# Rezoning Transportation Analysis

Petition Number: #2022-111

General Location Identifier: 05508105, 05508104, 05508103, 05508113

| Date     | Description        |
|----------|--------------------|
| 11-28-22 | First Review (PDM) |

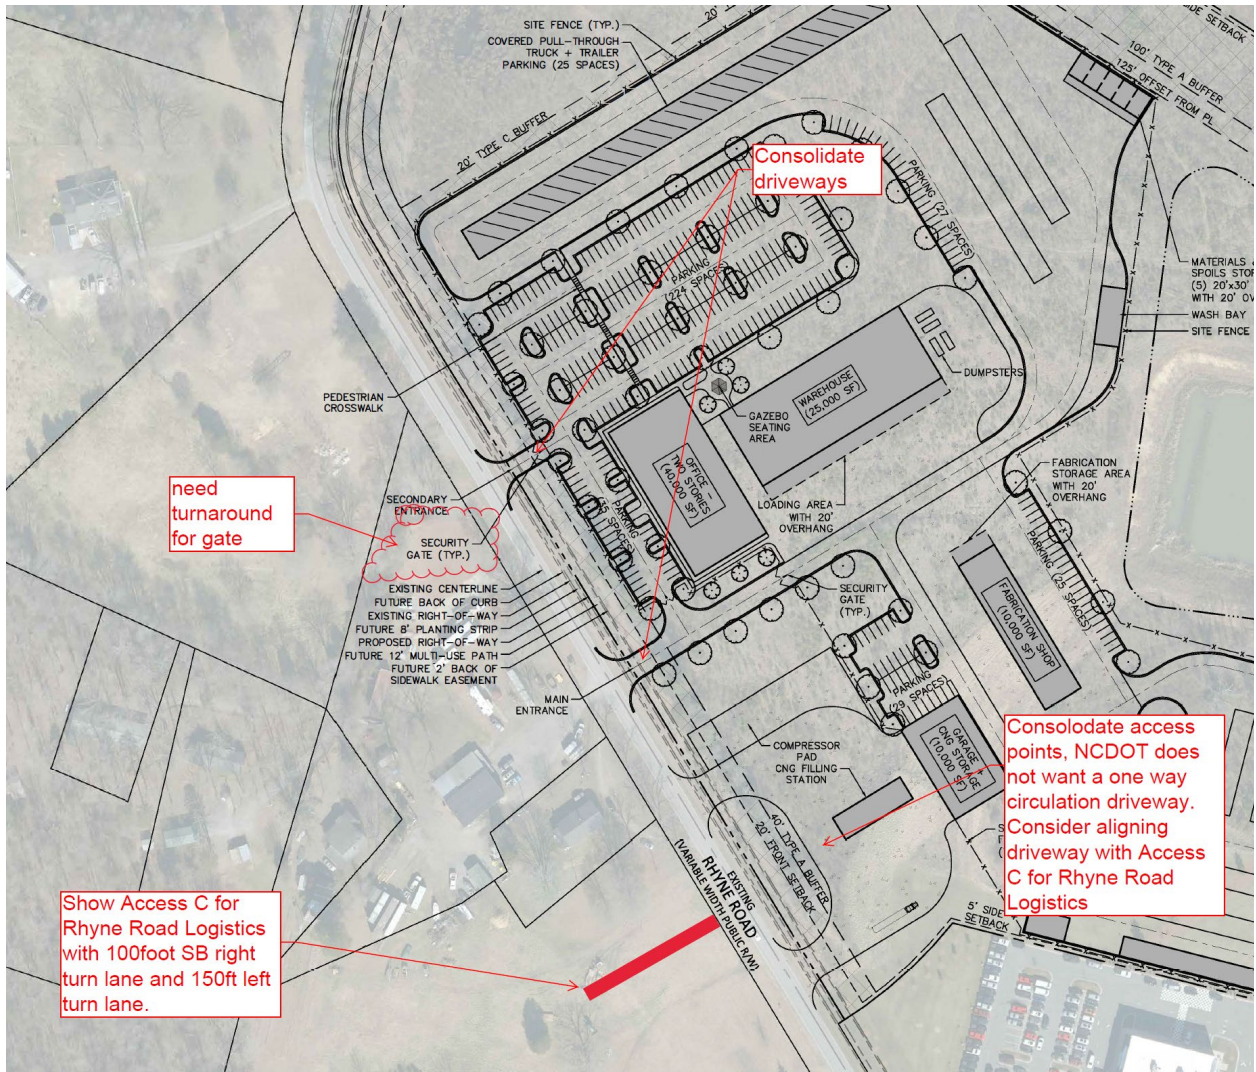
4. ~~Revise site plan and conditional note(s) to commit to construct an 8-foot planting strip, and 12-foot shared use path along the site's frontage of Rhyne Road. The site plan shall label and dimension each item from the back of curb. Clearly show the shared use path on the site plan.~~

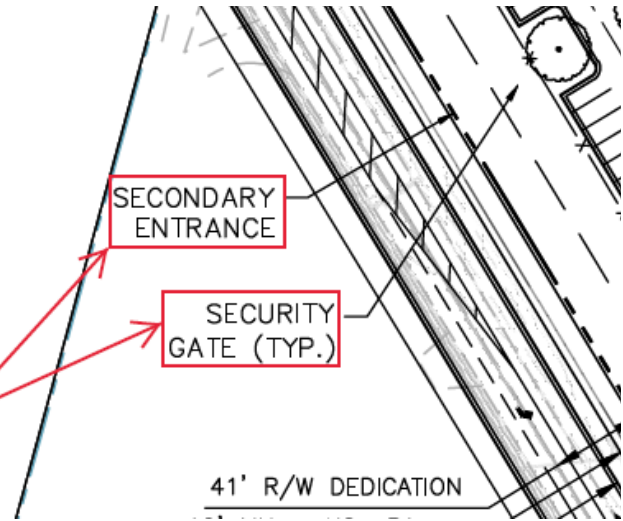
- New Comment from 12/22/2022:** Remove unnecessary callouts for security gate and secondary entrance as shown in image below.

Remove callouts for security gate and secondary entrance. Don't look like they are needed here anymore.

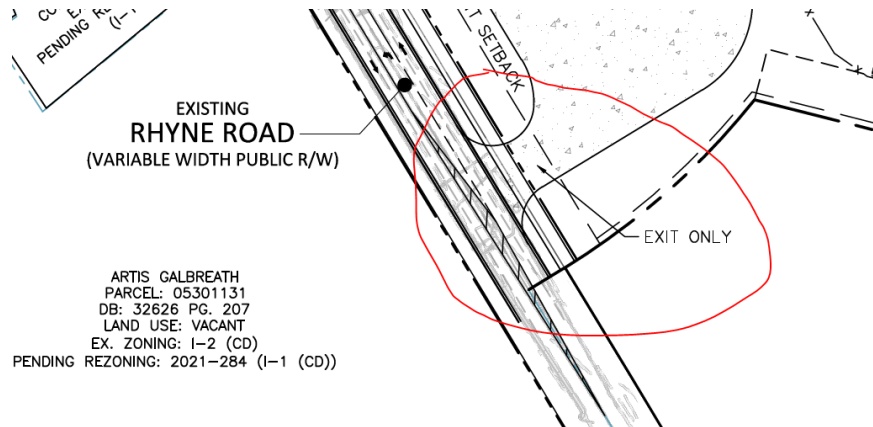
8. **New Comment from 12/22/2022:** The exit only driveway needs to be reconfigured to prevent potential ingress traffic or removed altogether.
